National Electricity Rules

Indicative mark up of changes made by the *National Electricity Amendment (Improving the NEM access standards – Package 1) Rule 2025*.

Figure S5.1a.1

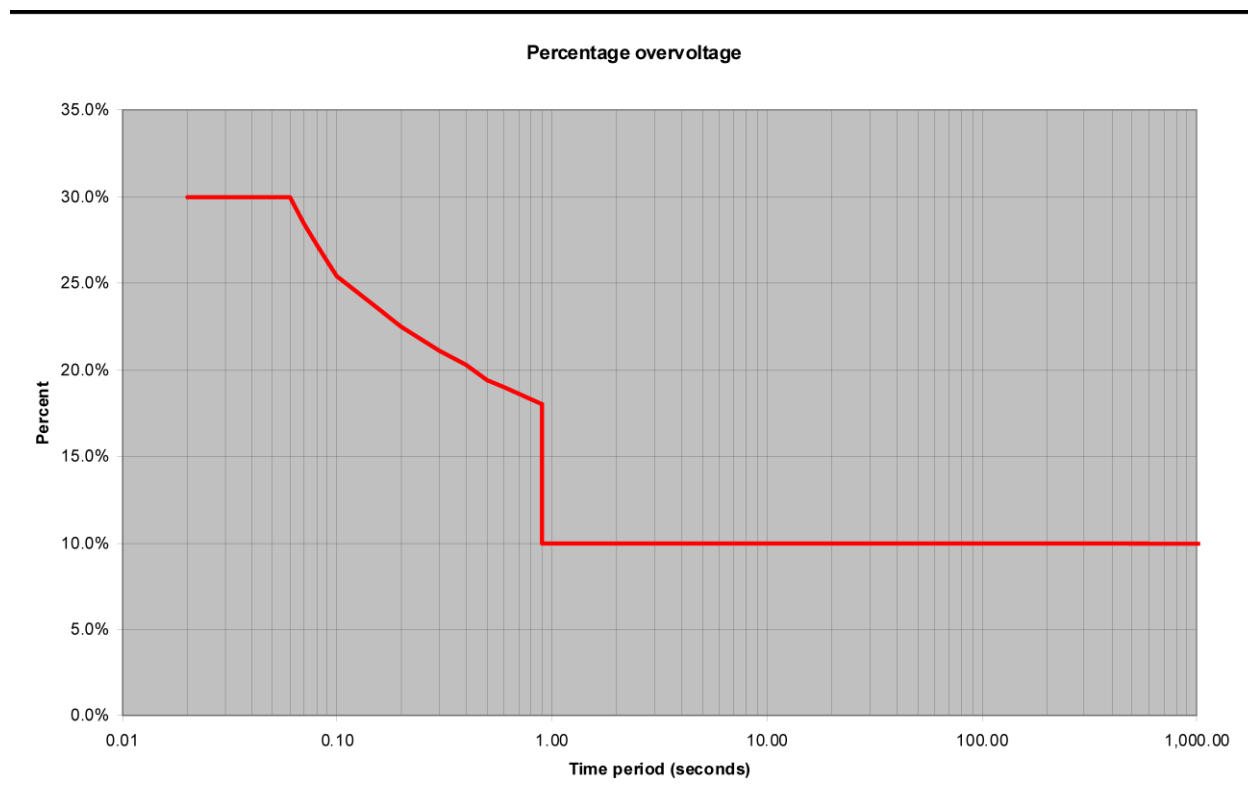
As a consequence of a *credible contingency event*, the ~~voltage-voltage~~ of supply at a *connection point* should not rise above its ~~normal-nominal~~ voltage by more than a given percentage of ~~normal- nominal~~ voltage for longer than the corresponding period shown in Figure S5.1a.1 for that percentage.

As a consequence of a *contingency event*, the ~~voltage-voltage~~ of supply at a *connection point* could fall to zero for any period.

Figure S5.2.1

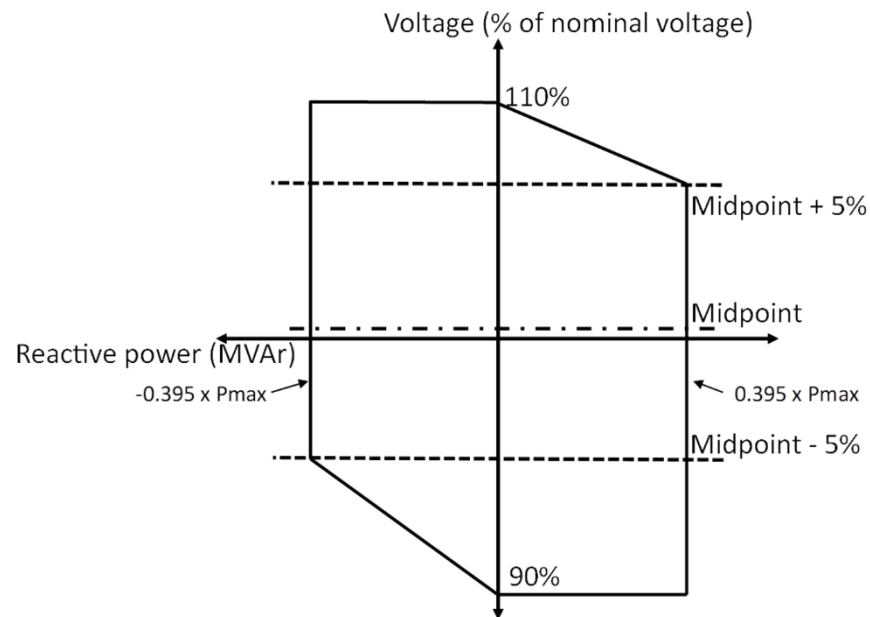
- (i) supplying an amount at least equal to the product of the maximum active power of the *schedule 5.2 plant* and 0.395; and
- (ii) absorbing an amount at least equal to the amount specified under sub-paragraph (i) at the lower limit of the voltage range in paragraph (1), decreasing linearly to zero at the lower limit established under clause S5.1a.4 without a *contingency event*,

as illustrated in Figure S5.2.1.
